# Access Compliance Report

## Public Rights-of-Way

Intersection ID: 24180	Main Street: CANDLEWYCK_LN	Cross Street: STONERIDGE_RD	Location: NW
ADA ID: 4AA2FD9BA113	Ramp Type: PerpDiag	Initial Pass/Fail: Fail	Overall Compliance: No
Severity Score: 25			
Codes/Mitigation Info/Possible Solution		Field Measurements/Component Compliance

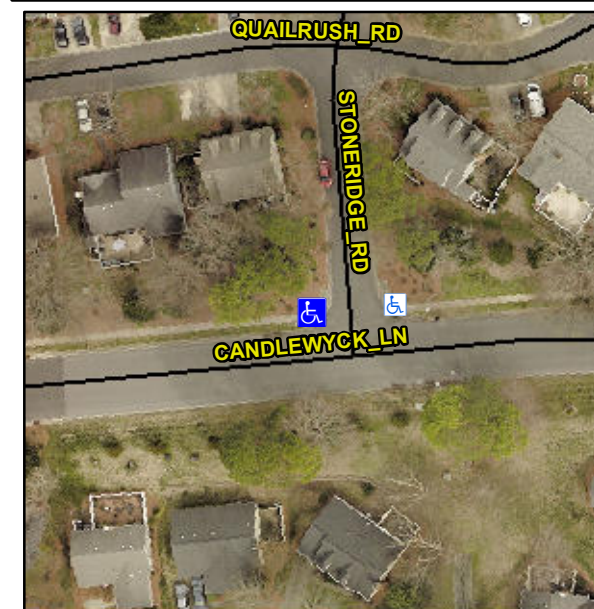
**R304.2.2, R304.5.3**

Compliance	Description	Data	Compliance	Description	Data
N/A	Ramp Length (in)	47.0	No	Ramp Slope (%)	10.3
Yes	Ramp Width (in)	48.0	No	Ramp XSlope (%)	5.1
N/A	Flare Type LT	N/A	N/A	Flare Type RT	N/A
N/A	Flare Slope LT (%)	N/A	N/A	Flare Slope RT (%)	N/A
N/A	Flare Traversable LT?	N/A	N/A	Flare Traversable RT?	N/A
N/A	Landing Length (in)	N/A	N/A	DWS Provided?	N/A
N/A	Landing Width (in)	N/A	N/A	DWS Contrast?	N/A
N/A	Landing Slope (%)	N/A	N/A	DWS Length (in)	N/A
N/A	Landing X Slope (%)	N/A	N/A	DWS Full Width?	N/A
N/A	Landing Curb? (Y/N)	N/A	N/A	DWS Offset (in)	N/A
N/A	Shared Landing?	N/A			
N/A	Gutter Ponding?	N/A	N/A	Gutter Slope (%)	N/A
N/A	Gutter Lip Ht (in)	N/A	N/A	Gutter X Slope (%)	N/A
N/A	Painted X Walk1?	No	N/A	Painted X Walk2?	No
	X Walk 1 Direction	To S		X Walk 2 Direction	To E
N/A	X Walk 1 Width (in)	N/A	N/A	X Walk 2 Width (in)	N/A
	X Walk 1 Slope (%)	3.9		X Walk 2 Slope (%)	3.1
	X Walk 1 X Slope (%)	2.5		X Walk 2 X Slope (%)	5.9

**Remove & Replace Curb Ramp With Two New Directional Ramps or Equivalent.**
